REMARKS

In the Office Action, the drawings were objected to based on the presence of extraneous matter in Figs. 1, 3 and 4. Claims 11-22 were rejected under 35 U.S.C. 112, second paragraph as being indefinite. Claims 1-10 and 23 were rejected under 35 U.S.C. 103(a) as being unpatentable over Karnes (6,600,642) in view of Wassing (4,527,215).

ANNOTATED SHEET SHOWING CHANGES

**FIG. 1****FIG. 2**

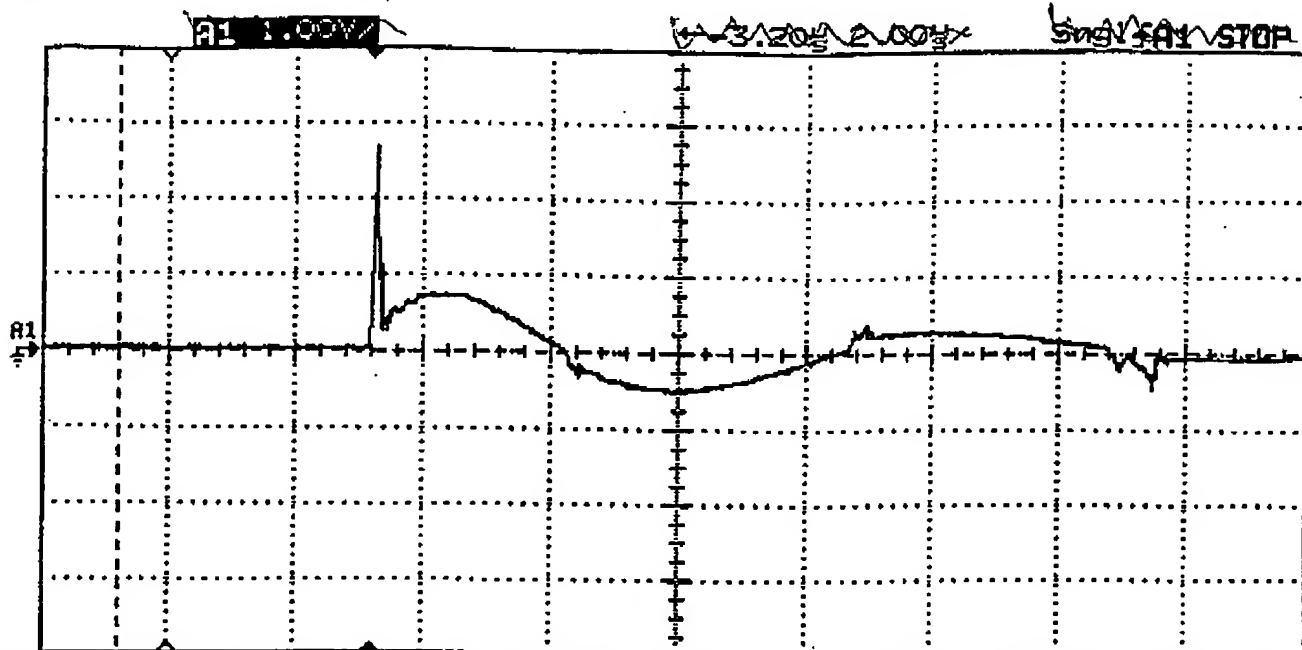
By the present amendment, replacement drawing sheets comprising Figs. 1, 3 and 4 have been submitted. In Fig. 1, the designation ".005" has been removed. In Fig. 3, the data sets regarding monitor settings and the designation "Plot 1" have been removed. In Fig. 4, the legend with symbols, the associated symbols, and the designation "Diagram 1" have been removed. Reference numbers 30 and 32 have been added to identify the air gaps. The specification has been amended to remove references to the designation ".005" being shown in Fig. 1, and to identify the reference numerals 30 and 32 added to Fig. 4. In view of the foregoing, it is believed that the drawing objections have been overcome.
